VIKING PREFERRED SERVICE

SERVICE BULLETINS

VIKING[®]
Preferred Service

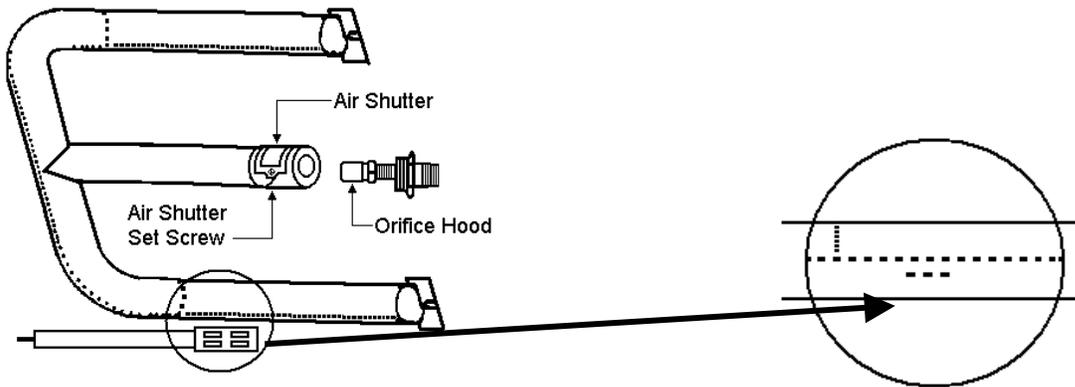
CORRECTION: Check for the three ports added opposite the spark igniter. If the three ports are not there, replace the bake burner with part #PB050059.

ILLUSTRATION #3

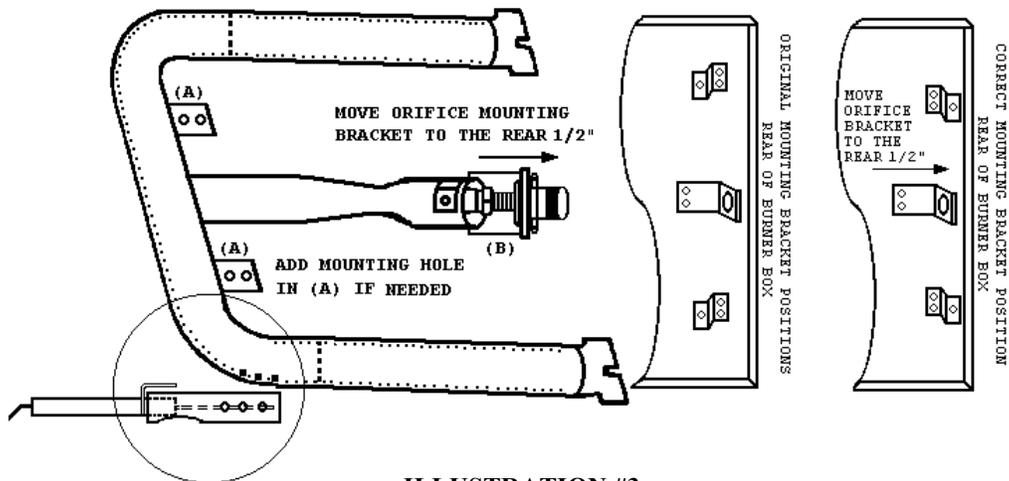
- Correction:**
- (1) Inspect the position of the igniter electrode to the burner ports (A, B, & C). Illustration #1 is incorrect. Illustration #2 is the correct position.
 - (2) Reverse the burner mounting "Z" bracket (See Illustration #3 Below).
 - (3) Move the Orifice mounting bracket toward the rear 1/2" and remount.
 - (4) Add another mounting hole in bracket (A) if needed.

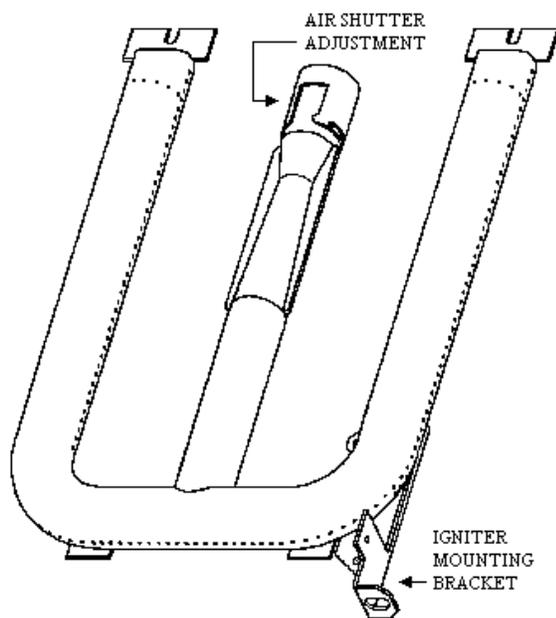
Correction: Install new Burner with welded igniter bracket:

1. Remove oven racks and rack supports.
2. Remove oven bottom pan assembly.
3. Remove burner cover.
4. Remove and save igniter for later installation.
5. Install new burner (with welded igniter bracket).
6. Re-install the saved igniter.
7. Replace burner cover and oven bottom pan assembly to check and adjust the air/gas mixture.

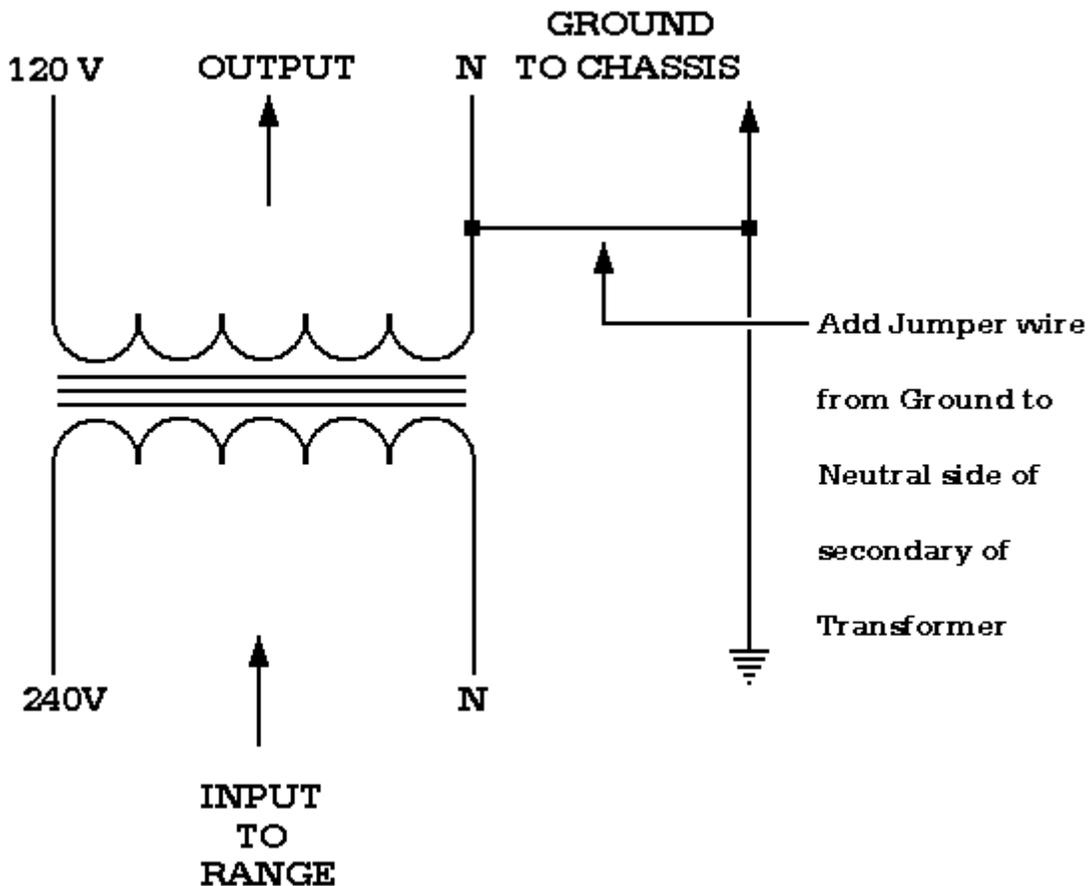
Correction: Add jumper wire from ground to Neutral side of Secondary of Transformer (See Diagram below).

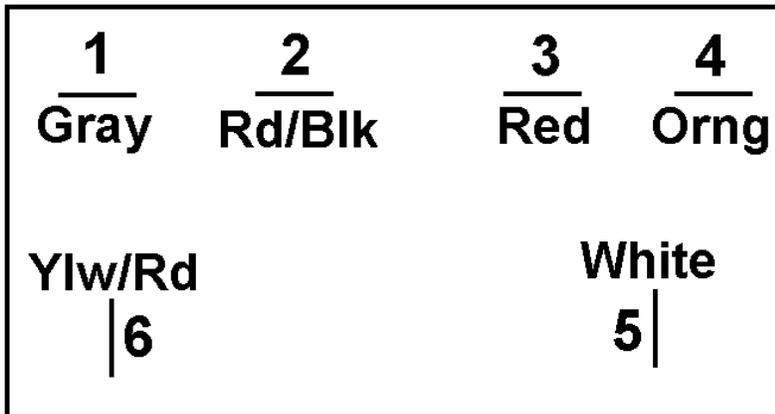
Solution: See diagrams below for proper installation of new relay:

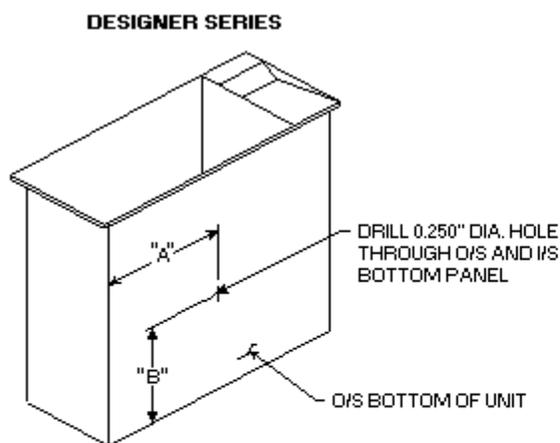
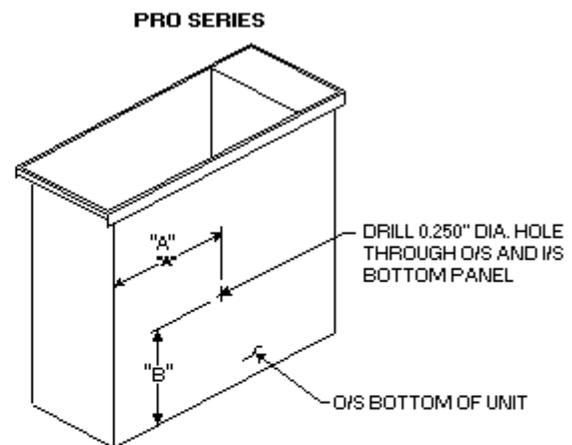
1. Disconnect the electrical power from the unit and remove from the cabinet.
2. Remove the door and/or pan assemblies.
3. Drill 0.250-diameter hole through the outside and inside bottom panel (see the attached drawing for dimensions).
4. Insert a #10-24 x 0.750" machine screw from the bottom of the unit and use a #10-24 nut on the inside of the unit to pull the two panels together.
5. Install the unit in cabinet and connect electrical power.

MODEL	"A"	"B"
DEWD170	11"	8"
DEWD100	12 1/2"	8"

MODEL	"A"	"B"
VEWD172	8 1/2"	10 1/2"
VEWD102	10"	10 1/2"
VEWD162	12"	10 1/2"

INSTRUCTIONS FOR REPLACING LD FILTER CLIPS WITH NEWLY DESIGNED CLIPS

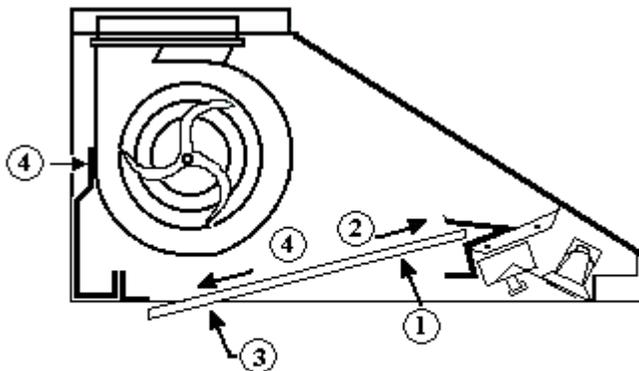
1. REMOVE EXISTING WIRE CHANNEL BRACKET
2. REPLACE WITH NEW WIRE CHANNEL BRACKET (SUPPLIED)
3. REMOVE EXISTING REAR FILTER SUPPORT
4. PLACE MOTOR STAND-OFF BRACKET (SUPPLIED) MAKING SURE HOLES ARE ALIGNED. (1/8 HOLES FOR 3010, O/S HOLES FOR 3610)
5. REPLACE WITH NEW REAR FILTER SUPPORT (SUPPLIED)

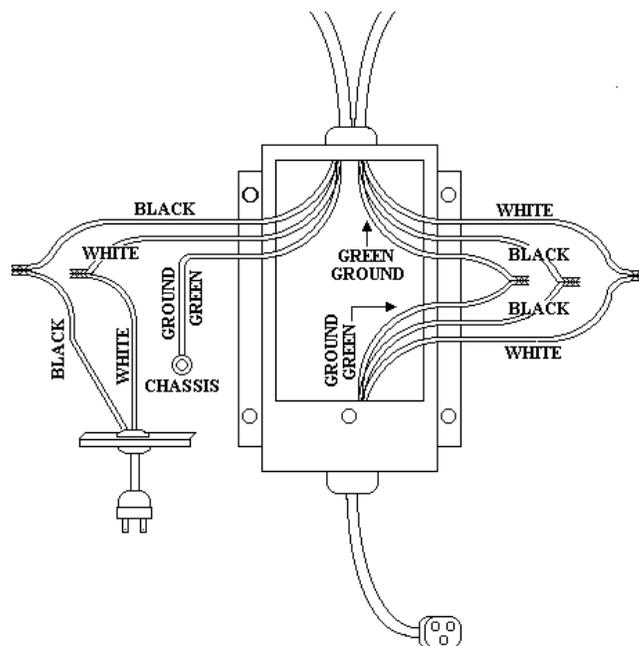
Correction: See Diagram)

1. **RIGHT SIDE OF DRAWING** – WIRES (BLACK, WHITE, AND GROUND) COMING FROM BREAKER SHOULD BE CONNECTED IN THE ELECTRICAL BOX TO THE 3 WIRES FROM THE CORD PLUGGED INTO THE CONTROL PANEL. BLACK TO BLACK, WHITE-TO-WHITE, AND GROUND TO GREEN AND CHASSIS.
2. **LEFT SIDE OF DRAWING** – WIRES (BLACK, WHITE, AND GROUND) COMING FROM EXTERIOR BLOWER SHOULD BE CONNECTED IN THE ELECTRICAL BOX TO THE 2 WIRE MALE CORD SUPPLIED WITH THE BLOWER. BLACK TO BLACK, WHITE-TO-WHITE, AND GROUND TO CHASSIS. THIS SHOULD BE PLUGGED INTO THE RECEPTACLE ON THE BACK OF THE CONTROL PANEL.
